Re: The Hub at Tucson III (No. T17SA00305) – March 2018 Design Package Changes

THE HUB AT TUCSON III

DESIGN PACKAGE - CHANGE SUBMISSION I **CHANGES TO OCTOBER 3, 2017 APPROVED DESIGN**

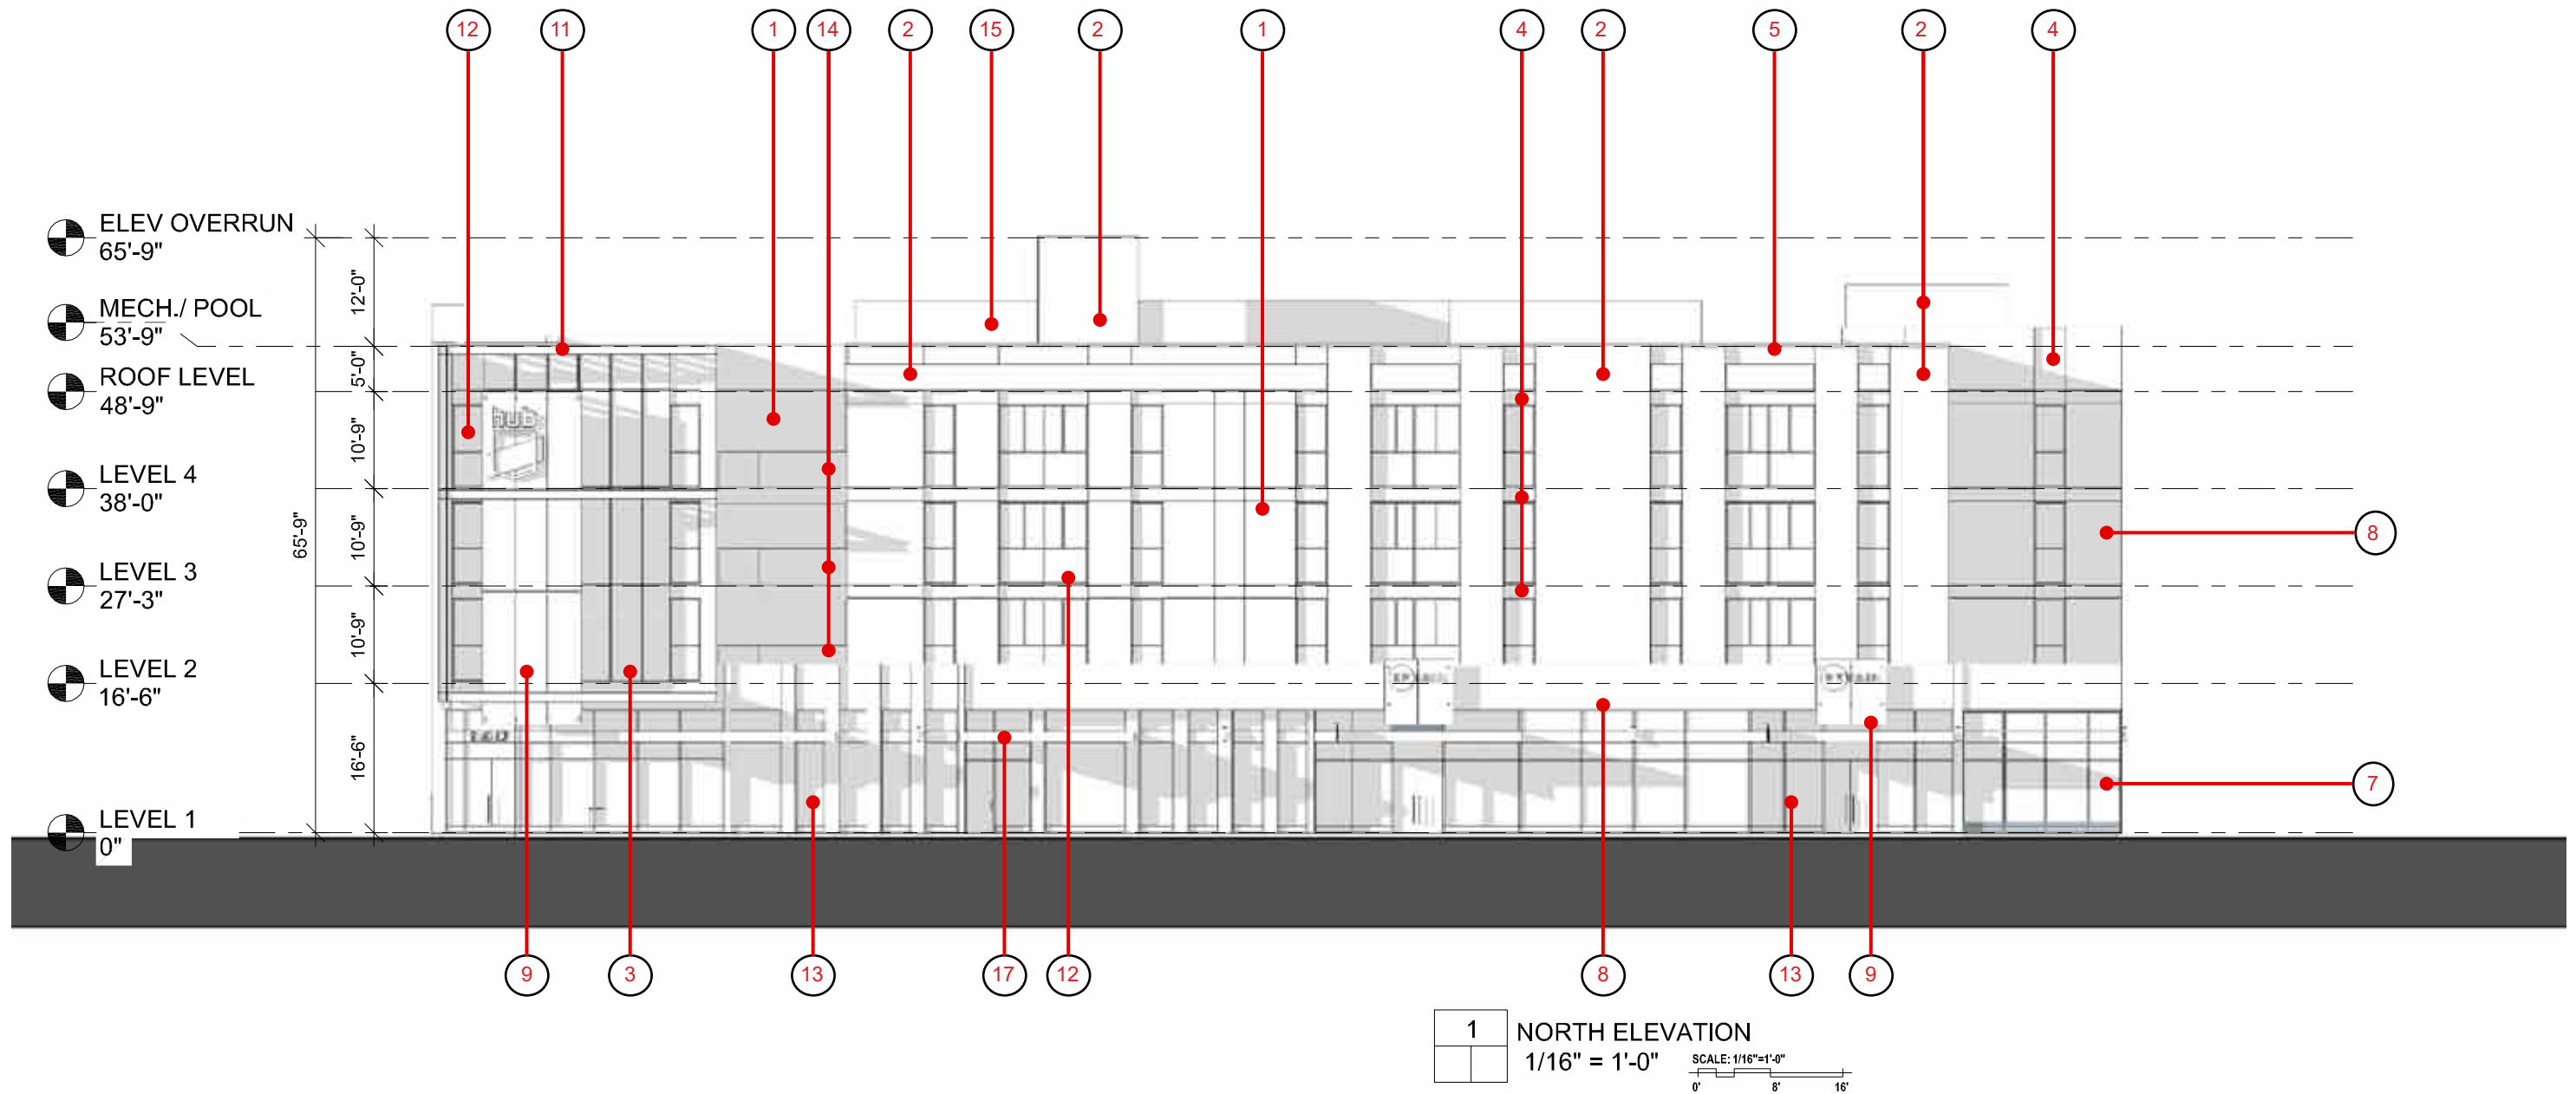
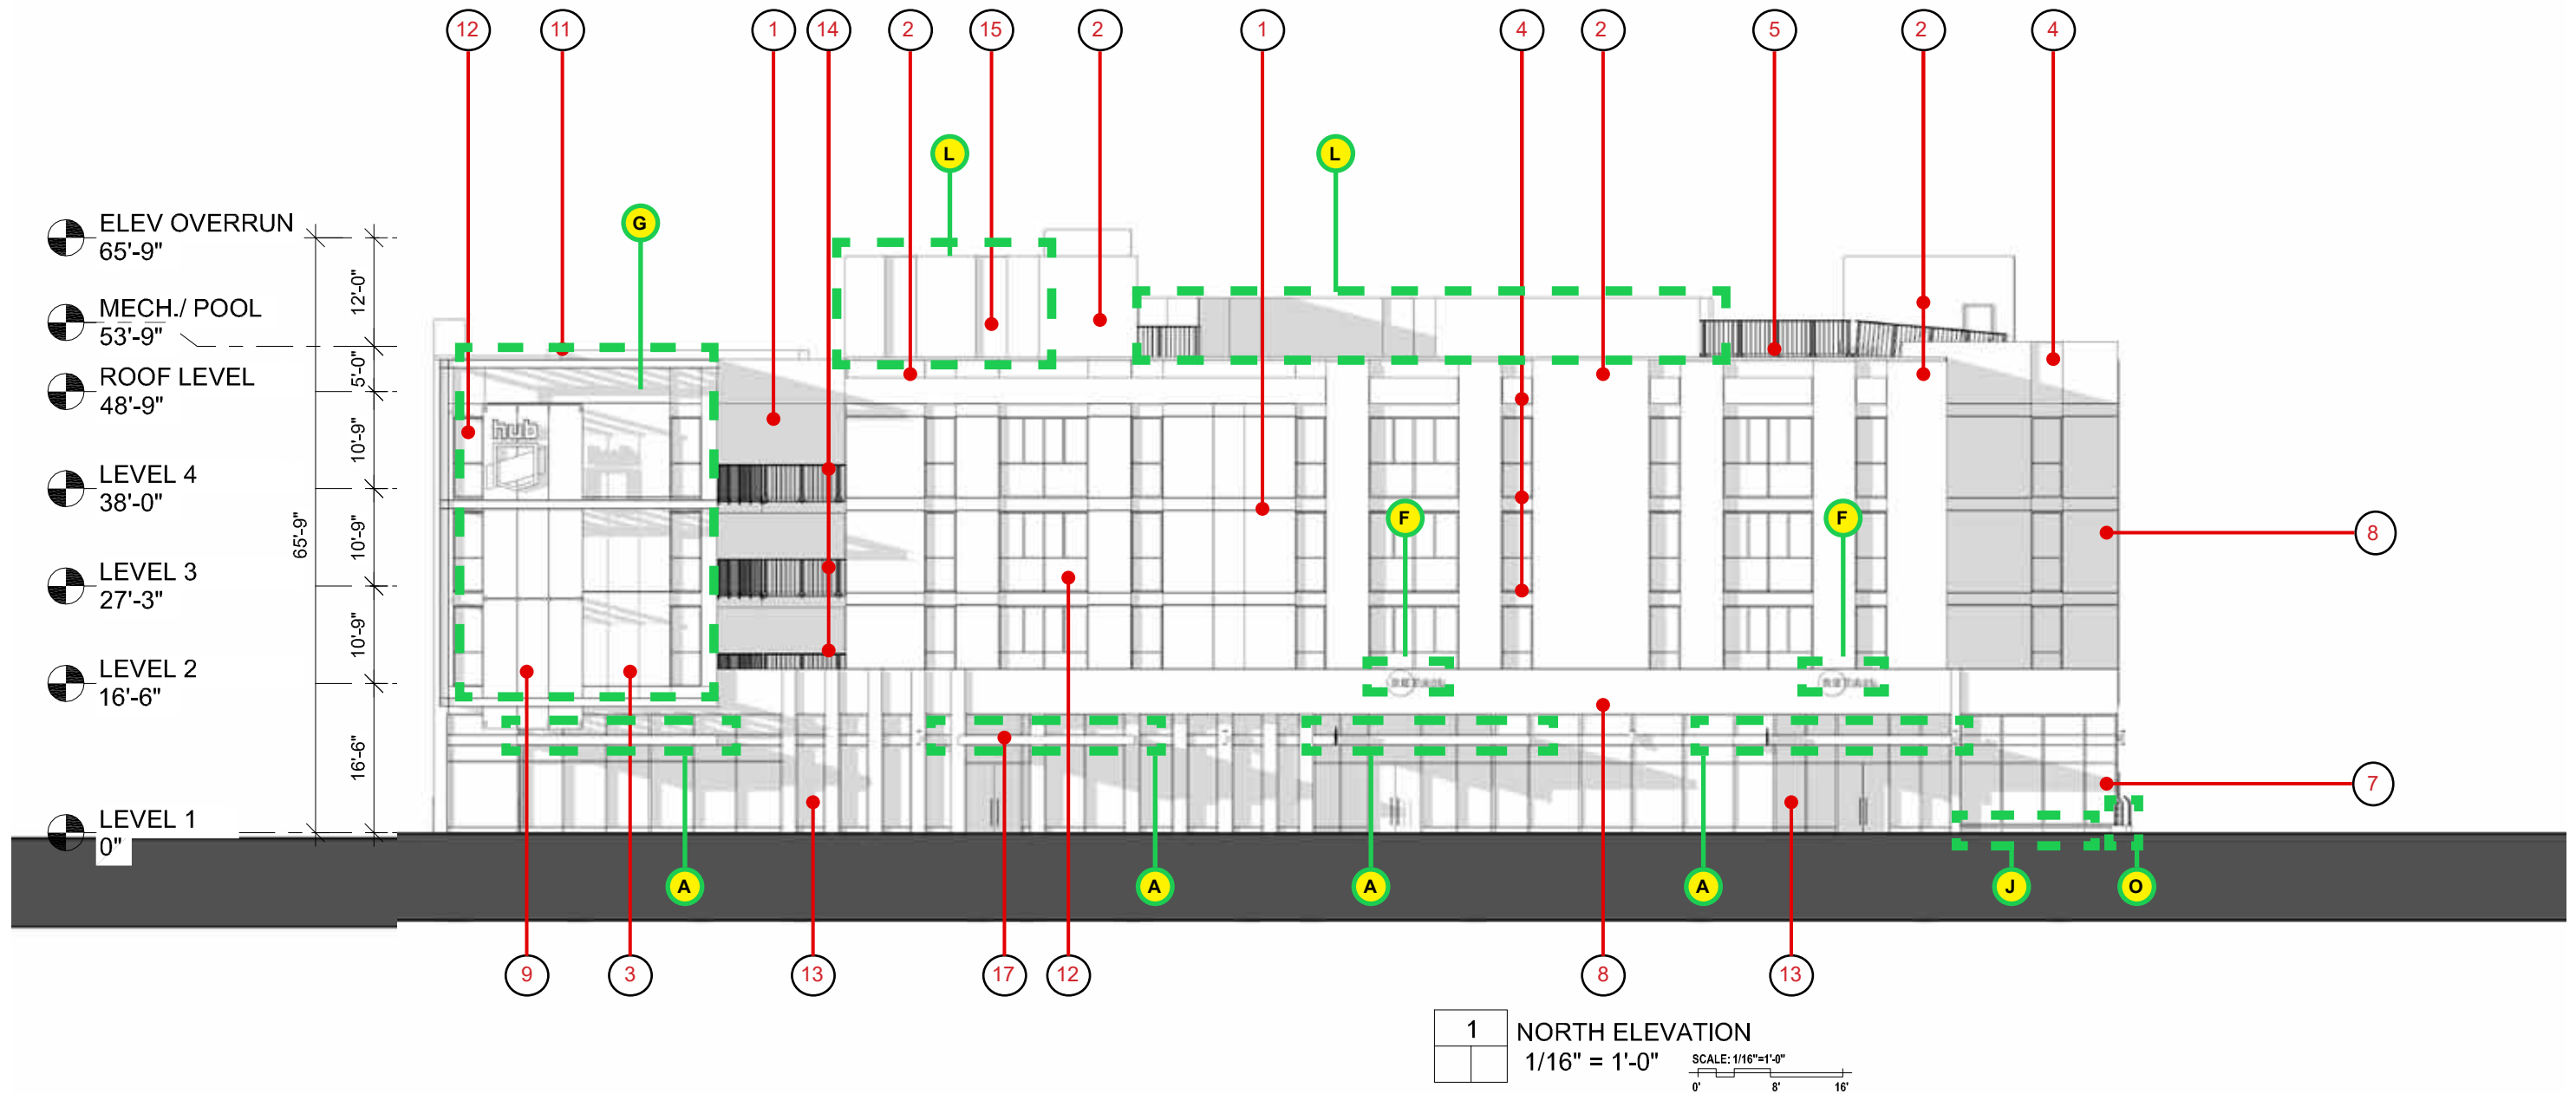
NORTH ELEVATION

A,F,G,J,L

1. Speedway Canopies - Location Adjustments (Item A): The location of the Speedway frontage shade canopies have been repositioned to align with other architectural elements on the Project’s north façade. This change occurs in two areas:

6. Retail Signage Background Panel Removed (Item F): The Project is removing the glass panels that were placed behind the retail storefront signage. The intent of these panels was to frame the retail signage, but panels have been eliminated because they could conflict or interfere with the future signage's design (which is yet unknown). Instead, the retail signage will be placed directly against the wall above the retail space. This is a minor design change that eliminates potential conflicts with future tenant signage.

7. Corrugated Panel "Reveals" Eliminated (Item G): The corrugated stucco panels above the Project's residential entrance were designed with a series of vertical gaps, or reveals. These reveals have been removed to create a consistent area of corrugated stucco above the entry. This is a design improvement that eliminates unnecessary and busy vertical lines above the residential entrance. No materials have been changed or eliminated, and therefore this is a minor change to the Project's design.

10. Transformer Planter Enlarged (Item J): The Transformer planter depth (facing Speedway) has been extended approximately 10 inches. The planter's original depth was eight inches, and has been extended to 18 inches. This minor change increases the planters' area, allowing it to retain additional water runoff and promote the growth of the plants within the planter. The general design and materials used for the planter will not change, and therefore this is a minor change.
